Model: GW-C4/K-C3.5L(18CPM)/K-C3.5L	Date: 09-Feb-11	No.: RB244001b
-------------------------------------	-----------------	----------------

Subject: Firmware Release Note: GDI Basic		Prepared by: M. Saiki	
From: MFP/Printer Tech Service Dept., 2nd Tech Service Sect.			
Classification:	<input type="checkbox"/> Troubleshooting <input type="checkbox"/> Mechanical <input type="checkbox"/> Paper path <input type="checkbox"/> Product Safety	<input type="checkbox"/> Part information <input type="checkbox"/> Electrical <input type="checkbox"/> Transmit/receive <input checked="" type="checkbox"/> Other (Firmware)	<input type="checkbox"/> Action required <input type="checkbox"/> Service manual revision <input type="checkbox"/> Retrofit information <input checked="" type="checkbox"/> Tier 2

Model: K-C3.5L		Date: 08-Nov-11	No.: RB244004
Subject: Parts Catalog Correction_Sheet-Operation Panel		Prepared by: M.Saiki	
From: 2nd Tech Service Sect., MFP/P Tech Service Dept.			
Classification:	<input type="checkbox"/> Troubleshooting <input type="checkbox"/> Mechanical <input type="checkbox"/> Paper path <input type="checkbox"/> Product Safety	<input checked="" type="checkbox"/> Part information <i

3.OPERATION PANEL

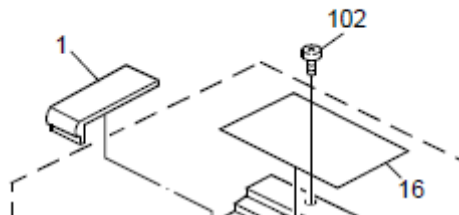
Old part number	New part number	Description	Q'ty	Int	Page	Index	Note
	B2441473	SHEET:OPERATION PANEL:CHN			13	16

Change/Reason: The part number was missing from the parts catalog.

See the following diagram for the corrected part.
